8-E-22-HZ
APPLICATION FOR CERTIFICATE OF APPROPRIATENESS

1315 Forest Ave. 37916
Ft. Sanders NC

Original Print Date: 8/5/2022
 Knoxville/Knox County Planning -- Historic Zoning Commission

Level II Construction of Addition or Outbuilding, Major Repair or Replacement
Exterior rehabilitation of existing house and new rear addition.

① SITE PLAN
1/16" = 1'-0"

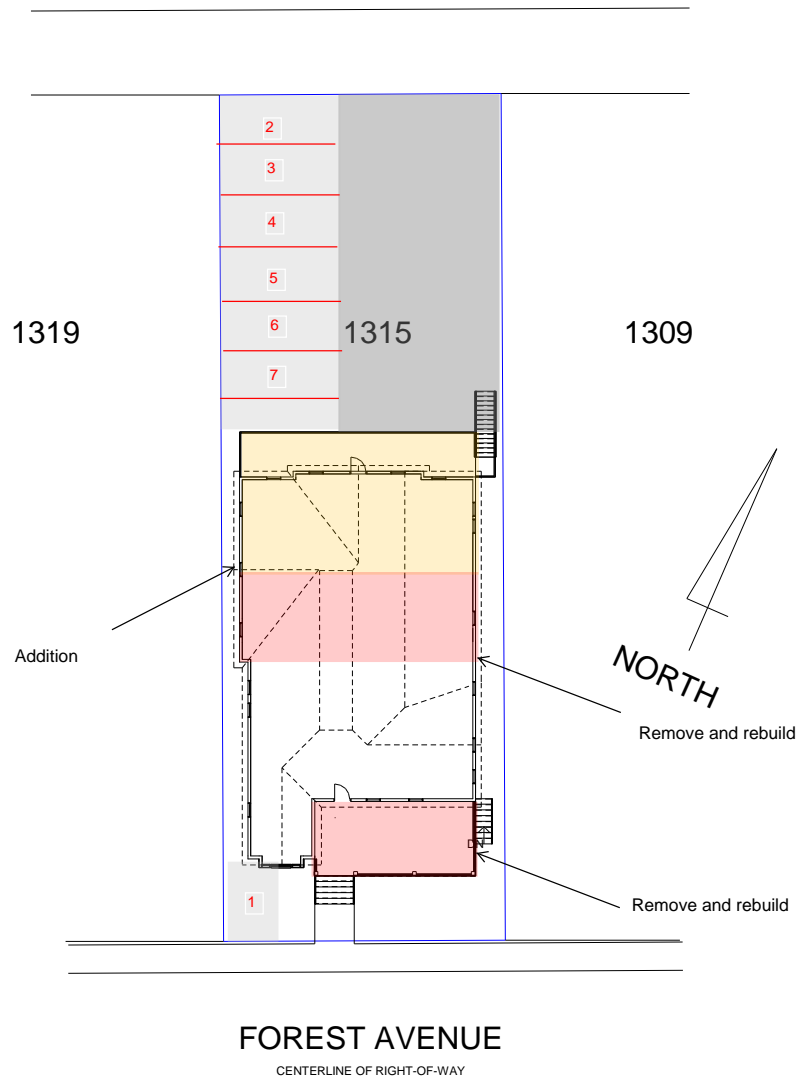
9. Final modifications to the site plan will be necessary to meet City Engineering standards for parking. The house and parking area need to remain below 45% impervious surface for the RN-5 zoning. The final site plan could be approved by staff, provided there are no substantial modifications to the addition's design and placement.
-

Staff recommends approval of Certificate 8-E-22-HZ, subject to the following conditions: 1) use of historically appropriate cornerboards, window trim, and door trim; 2) incorporate two windows instead of one on third-story gable field of west elevation; 3) revision to front porch roof and columns to be more comparable with historic designs, with approval by staff; 4) final site plan to meet City Engineering standards for parking and remain within impervious surface limits; 5) selection of a façade door to meet design guidelines, with approval by staff.

④ FRONT ELEVATION
1/8" = 1'-0"

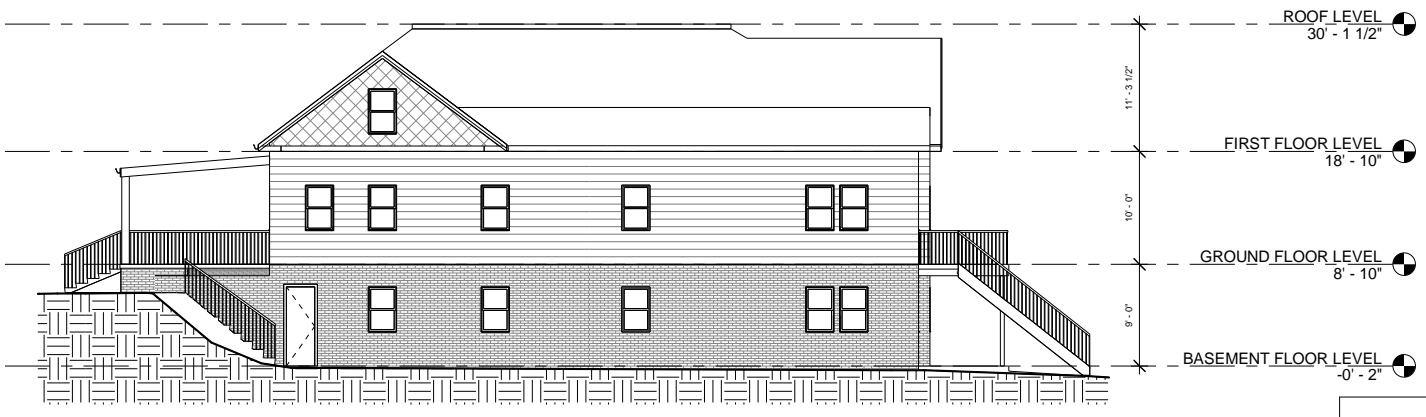
5. Removal of the non-historic enclosed front porch and side addition meets the design guidelines. Reconstruction of a front porch meets the design guidelines, which recommend to "provide porches with proportions and materials which complement pre-1940 houses." The flat porch roof would benefit from additional depth, whether revising the roofline to be a hip, gable, or shed roof with a higher pitch. The new porch columns should receive additional detail (turned wood posts, larger square columns, chamfered details, etc).

8. The replacement door on the façade should meet design guidelines ("similar proportions and features to pre-1940 architecture"). The new addition's roof should include ~1' eave overhangs on all elevations.

② SIDE ELEVATION 2
1/8" = 1'-0"

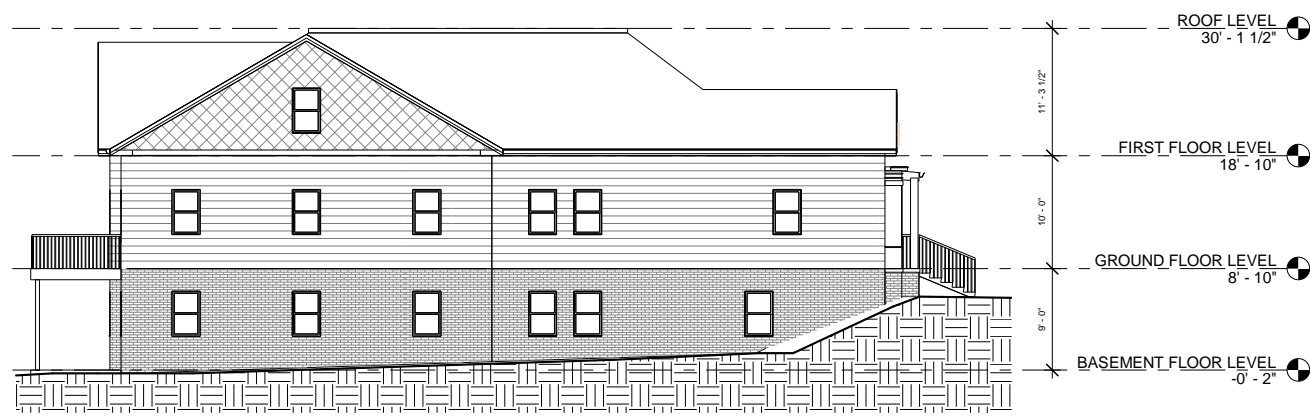
4. On the west elevation (side elevation 2), two windows instead of one in the third-story gable field (similar to the rear elevation) would break up a wide swath of siding. The applicant should clarify the design, materials, and operation of the new bay window on the façade, including the bulkhead area.
